## I. Proposal

## II. Justification

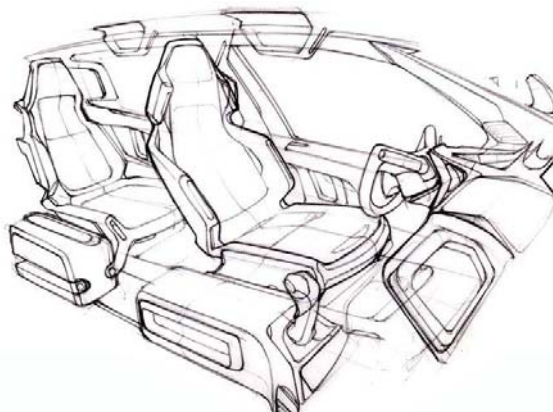
**"5.3.8.8. Notwithstanding paragraph 5.3.8.1., if a vehicle is only equipped with one seat position per row no ISOFIX position is required."**

Paragraph 5.3.8.8: Currently Regulation 14 requires vehicles with 2 seat rows of only 2 seats fitted in single file must be fitted with 2 ISOFIX anchorages. Consequently the only way to comply would be to fit an ISOFIX anchorage in the driver's position. See Figure below.
